December 18, 2025  
Project No. 2402308

**Re:      Peer Review Comments**  
**Maximum Predicted Water Table and Hydrogeological Assessment Report**  
**Proposed Class 'A' Pit Above Water (Watson Pit), Teeswater Concrete Ltd.**  
**311804 Highway 6, Mt. Forest**  
**Municipality of West Grey, Grey County**

# Technical Memo

**Re:** Hydrogeology Assessment of Proposed Class "A" Pit  
311804 Highway 6, Mt Forest  
Municipality of West Grey, Grey County  
GEI Project No. 2402308

POST -  
DEVELOPMENT  
DRAINAGE PLAN  
Figure No. 2

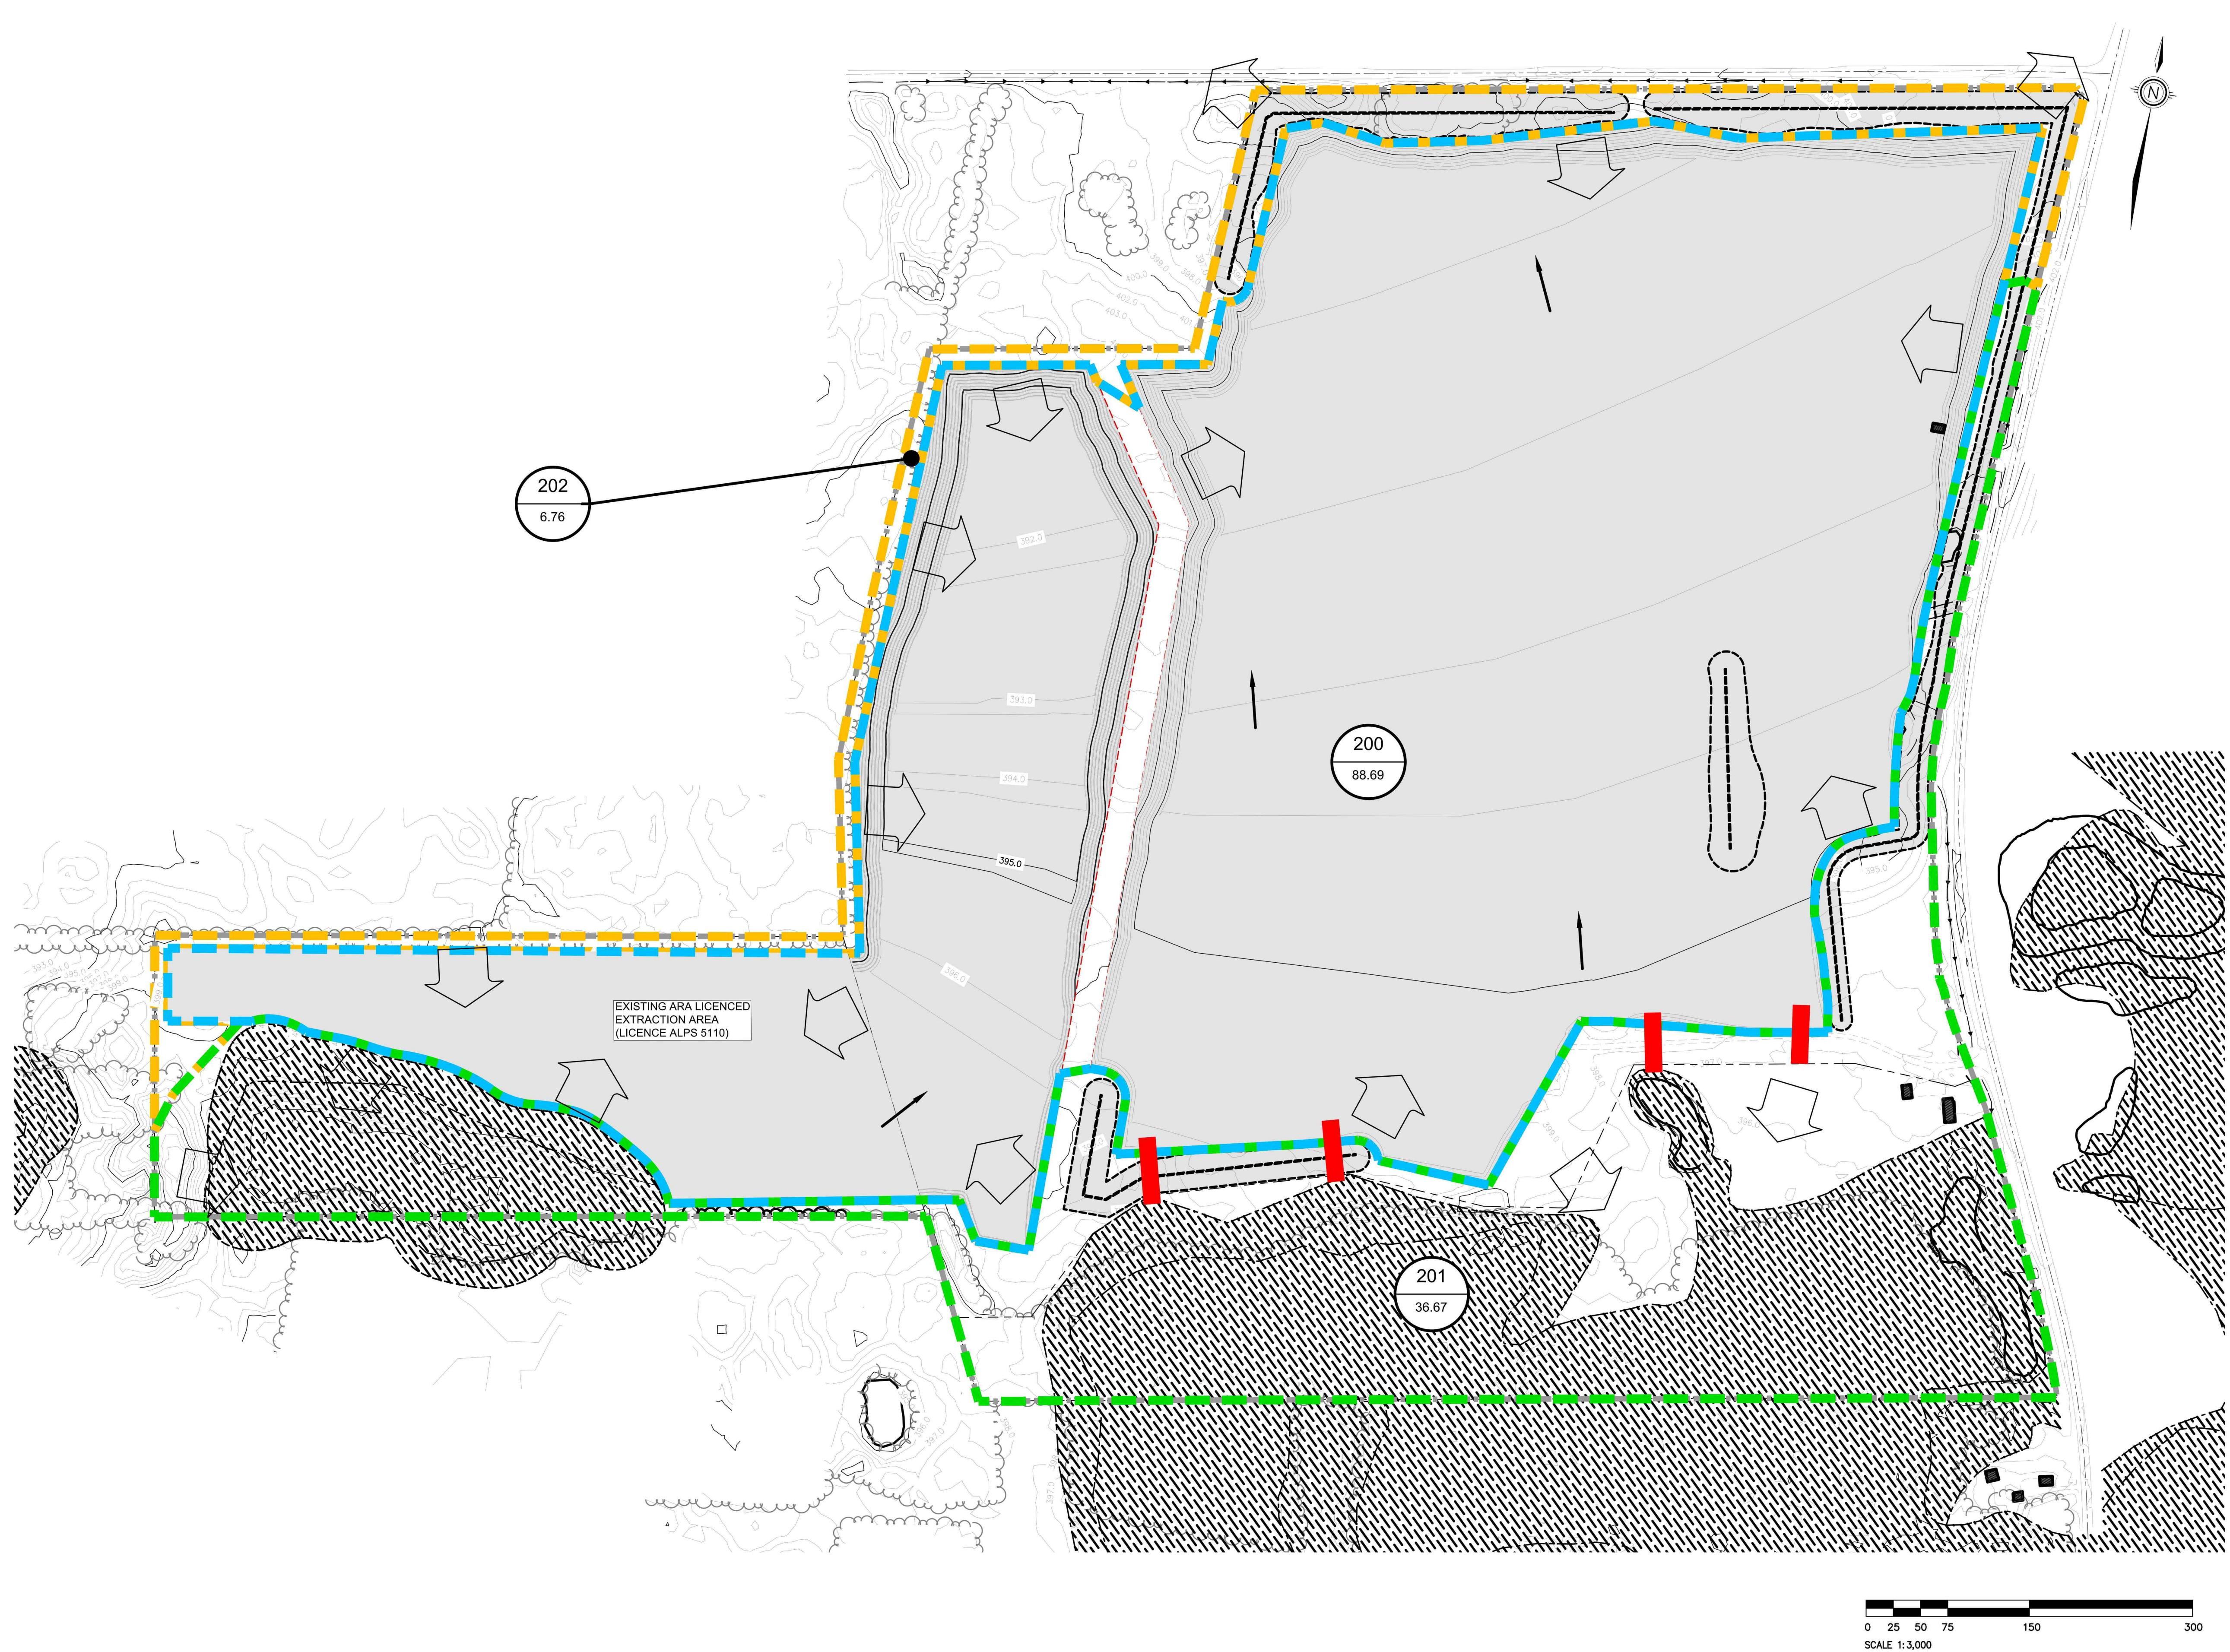
Figure 1 and 2 of the October 28 technical memo indicated that similar pre and post development catchment areas will not be maintained. If the above-noted recommended mitigative measure from the hydrogeological report will remain on the site plans, then details should be provided on how that recommendation will be achieved. If the recommendation will be removed from the site plans, then we have no further comment.

- A recommended mitigative measure from the hydrogeological assessment report indicated that restored grades shall be sloped to maintain similar pre- and post-development catchment areas was inconsistent with the findings of the October 28 water balance assessment. If that recommendation will remain on the site plans, then details should be provided on how that recommendation will be achieved.

The hydrogeological report and site plans will be revised based on the peer review process. Once the peer review process is completed the appropriate revisions will be made.

To address concerns regarding runoff volume decreases to the south, four (4) 300 mm balancing pipes will be installed under the basin berm along the southern boundary. These balancing pipes will convey flow to the south during precipitation events – 5mm or above which generate runoff and cause basin ponding.
